MRP 2016-039

SUBJECT: Transmittal of *Materials Reliability Program: Topical Report for Primary Water Stress Corrosion Cracking Mitigation by Surface Stress Improvement (MRP-335 Revision 3-A)*, EPRI, Palo Alto, CA: 2016. 3002009241.

2. U.S. NRC, Final Safety Evaluation of the Electric Power Research Institute MRP-335, Revision 3, "Materials Reliability Program: Topical Report for Primary Water Stress Corrosion Cracking Mitigation by Surface Stress Improvement [Peening]" (TAC No. MF2429), August 24, 2016. [NRC ADAMS Accession No.: ML16208A485]

Figure 4-1
Required Peening Coverage Zone for RPVHPNs with Incidence Angle, θ , ≤ 30 deg (Except Head Vent Nozzles) and for All RPVHPNs with Outer Diameter ≥ 4.5 in. (115 mm)

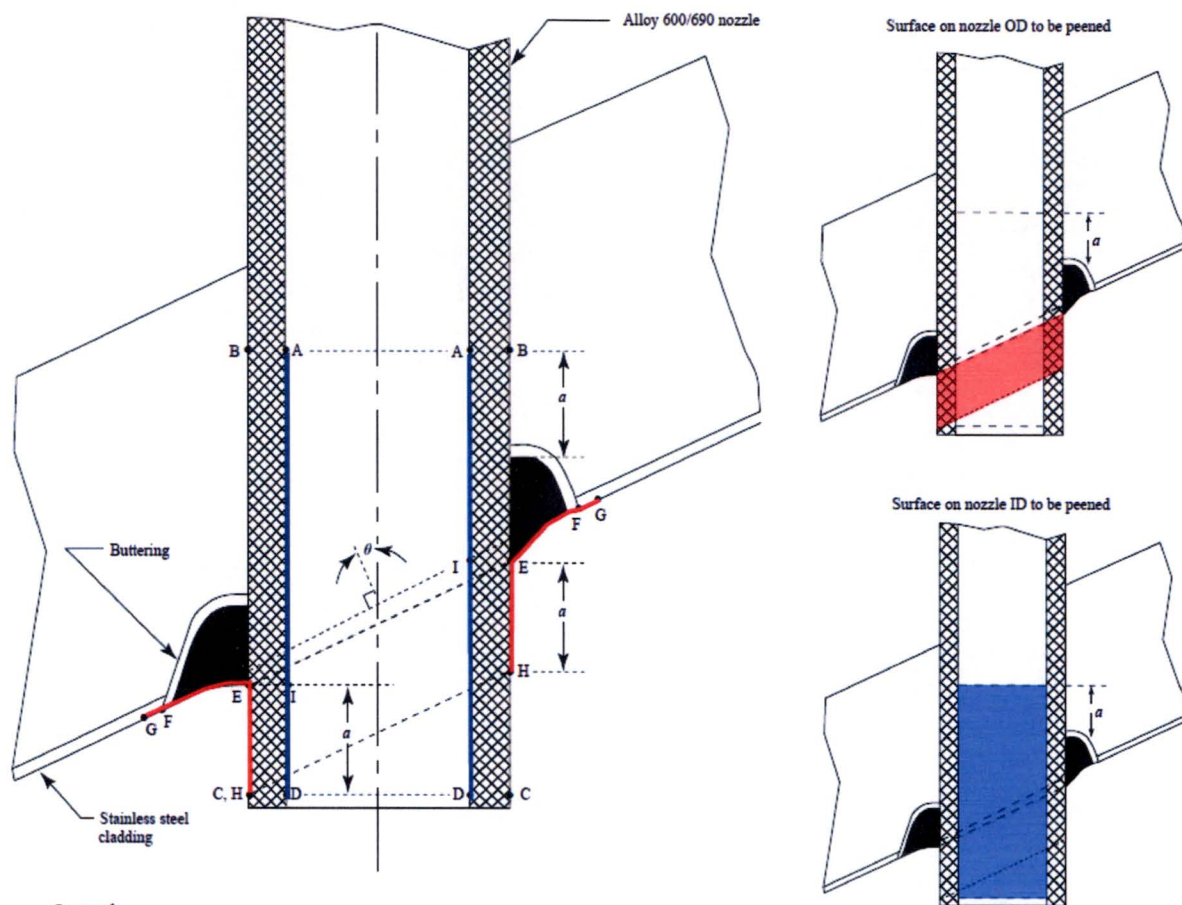
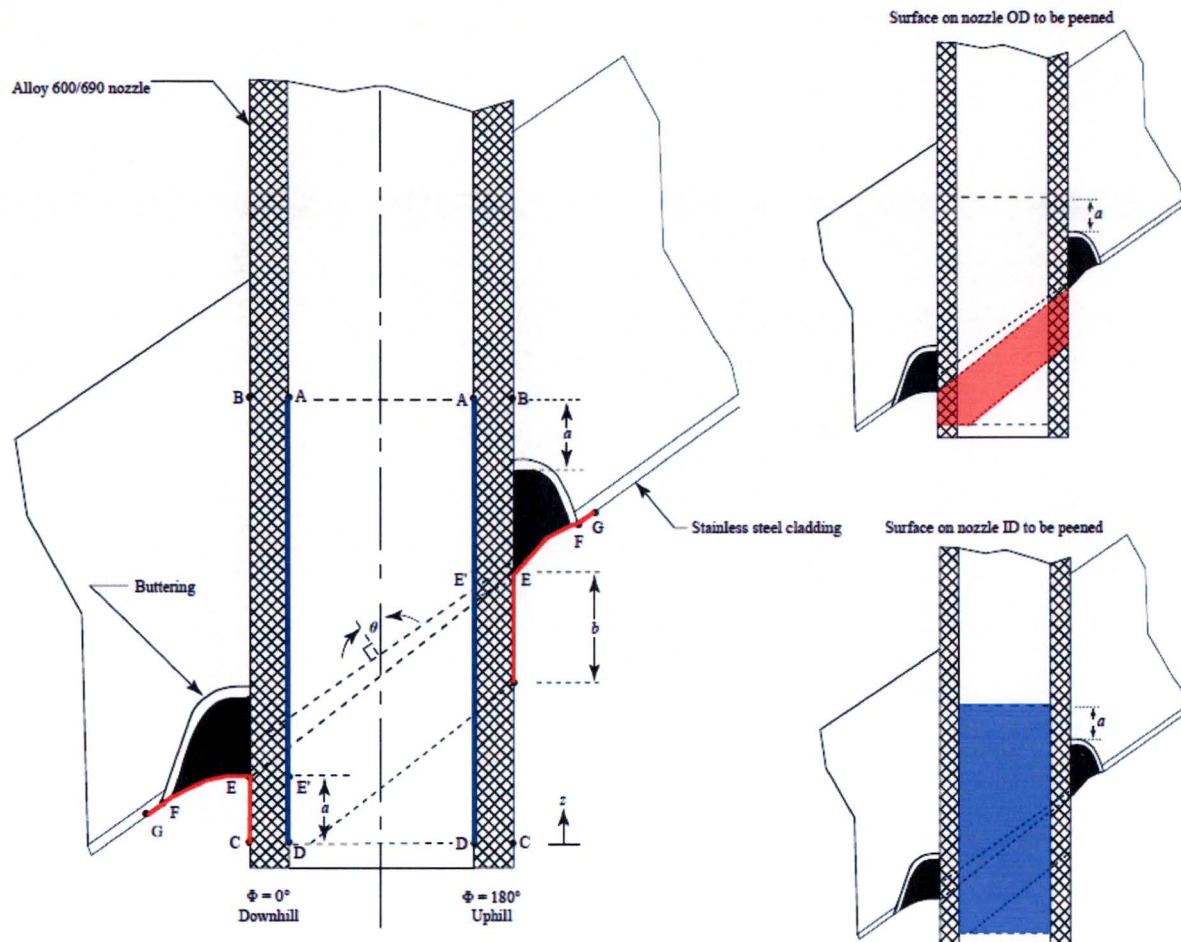
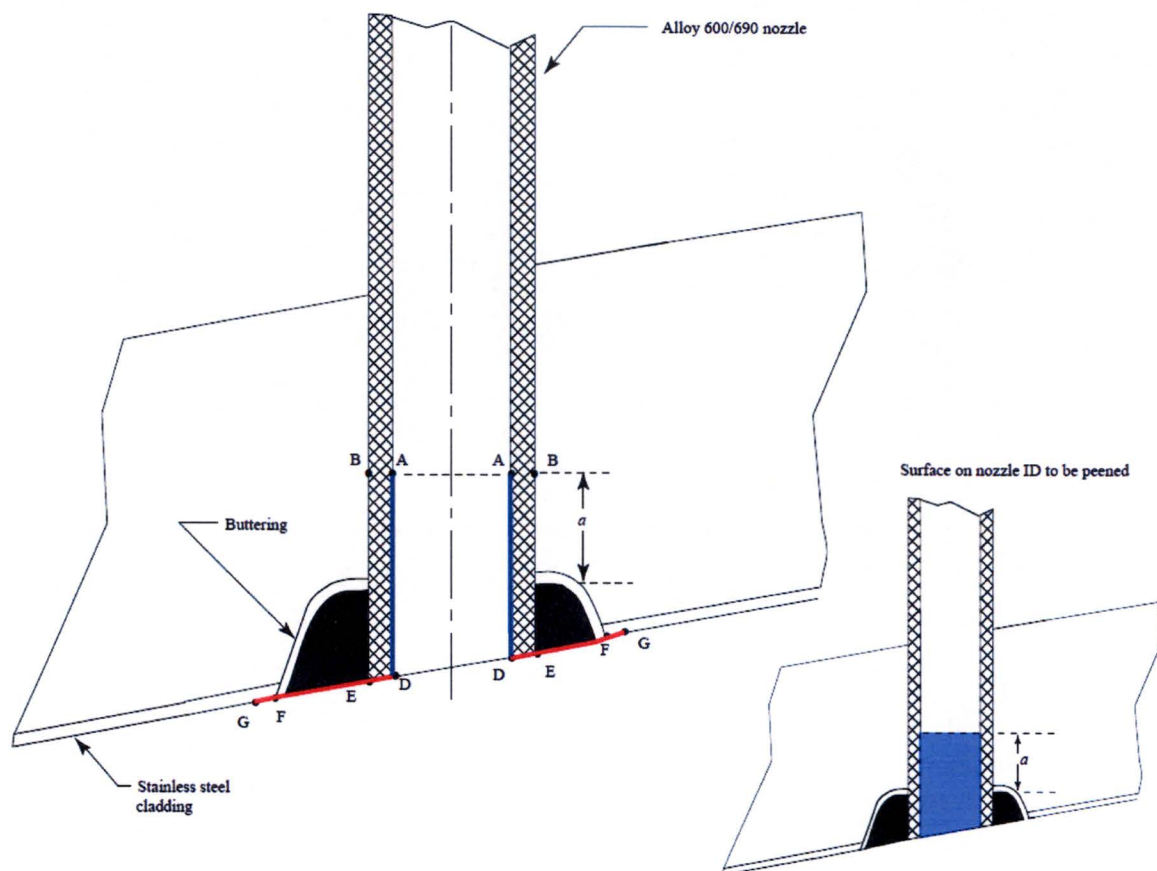
The MRP stated that the required peening coverage is the full wetted surfaces of the attachment weld, butter, and nozzle base material in the region defined in Figure 4-1 through Figure 4-4 of MRP-335R3. The MRP specified the peening coverage to ensure that areas susceptible to PWSCC initiation are mitigated. Section 4.3.8.1 of MRP-335R3 requires that the boundaries of the area required to be effectively peened in Figure 4-1 through Figure 4-4 be extended a suitable distance for the specific peening method to provide high assurance that the areas susceptible to PWSCC receive the required peening effect.

The NRC staff finds that the peening coverage is adequate because Figure 4-1 through Figure 4-4 of MRP-335R3 show the susceptible surface areas of the RPVHPN and J-groove weld that will be peened.

The required coverage is the full wetted surfaces of the attachment weld, butter, and nozzle base material in the region defined in Figure 4-1 through Figure 4-4. As discussed in Section 2.3.3, these coverage figures were specified to ensure that areas susceptible to PWSCC initiation are mitigated. Section 4.3.8.1 requires that the boundaries of the area required to be effectively peened in Figure 4-1 through Figure 4-4 be extended a suitable distance for the specific peening method to provide high assurance that the areas susceptible to PWSCC receive the required peening effect.

Figure 5-35
Low, Median, and High Pre-Peening Stress Profiles Applied in Deterministic Matrix for RPVHPNs (ID Uphill)

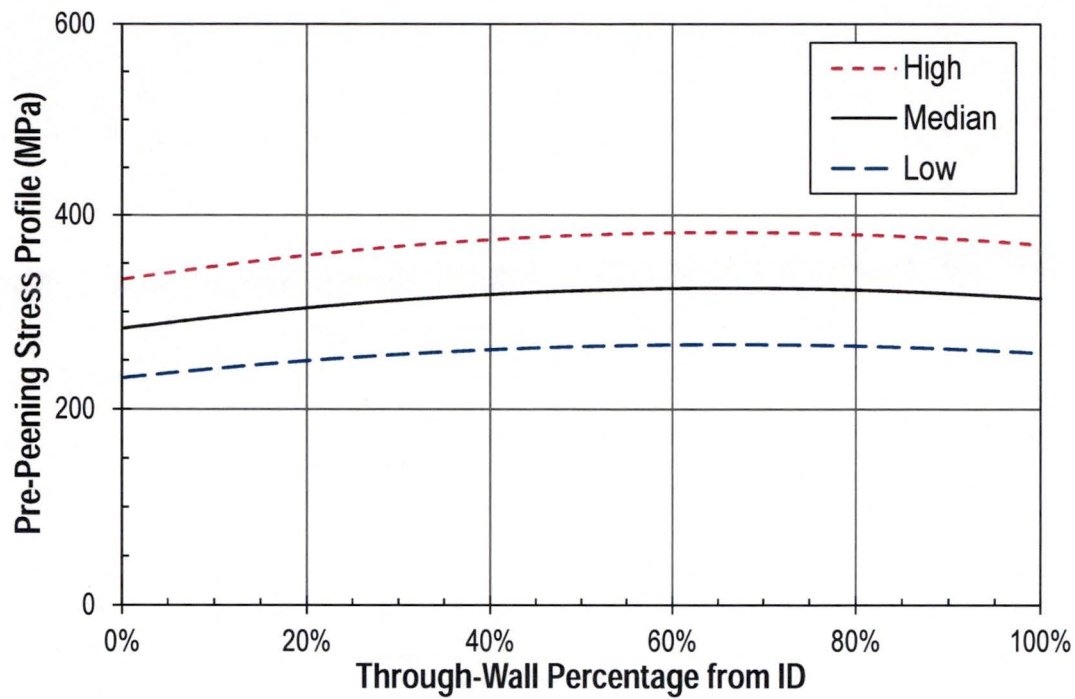
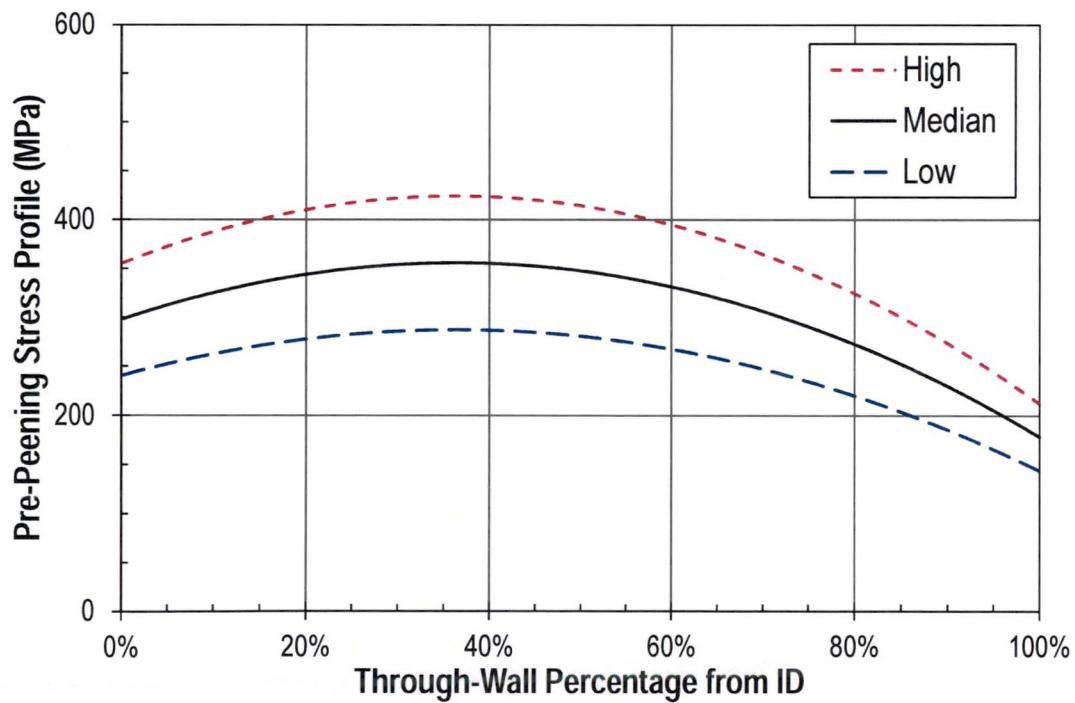
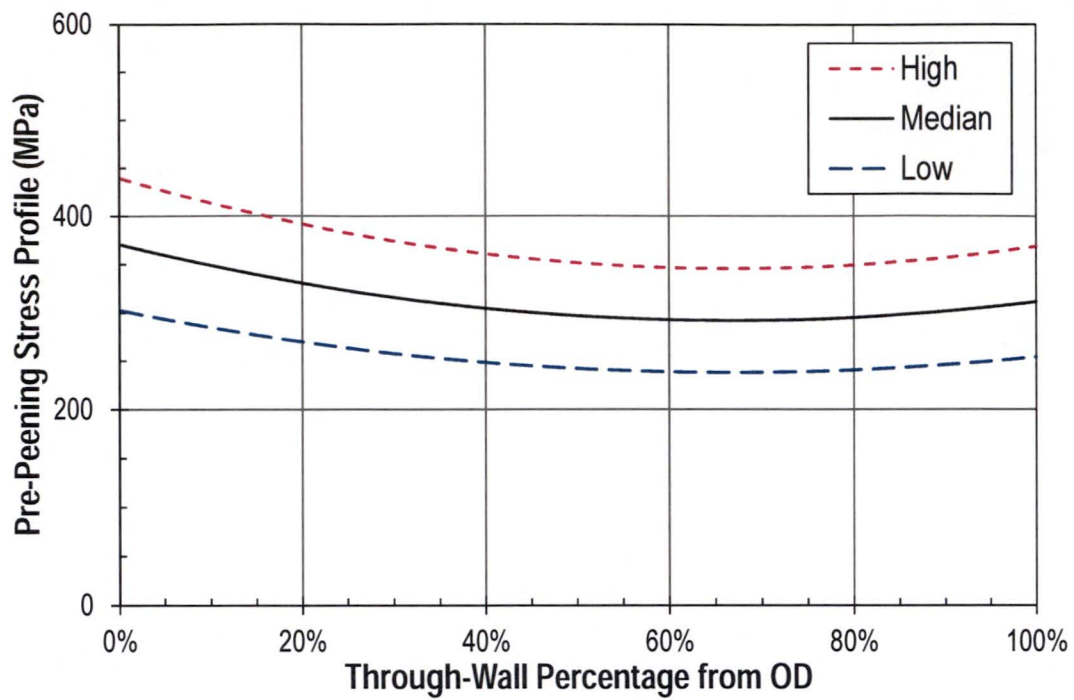
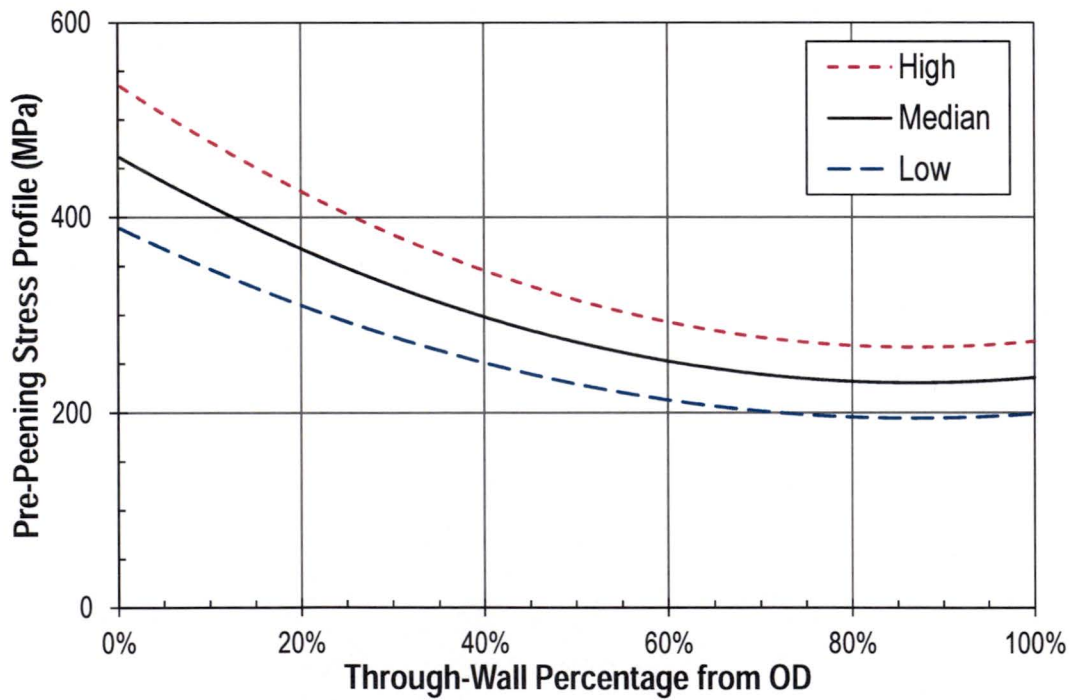
Of particular note was the NRC staff's comparison of the residual stress profiles in Figure 5-35 through Figure 5-38 of MRP-335R3 with the residual stress profiles of MRP-95, Revision 1. Appendix A of MRP-95R1 provides the residual stress profiles for four limiting plants. The stress profiles in Figure 5-35 through Figure 5-38 present the mean and plus one standard deviation and minus one standard deviation stress profiles calculated using a finite element analysis. The variability of the stress profiles from inside to outside diameter of the RPVHPN are significantly more varied in MRP-95R1 than those used in Figure 5-35 through Figure 5-38 in part because MRP-95R1 reported bounding profiles while Figure 5-35 through Figure 5-38 used a single standard deviation level for the limiting analyses. As such, the NRC staff finds the weld residual stress profiles for the deterministic calculations in MRP-335R3 were neither high enough nor low enough to bound the stress profiles of the peened RPVHPN.
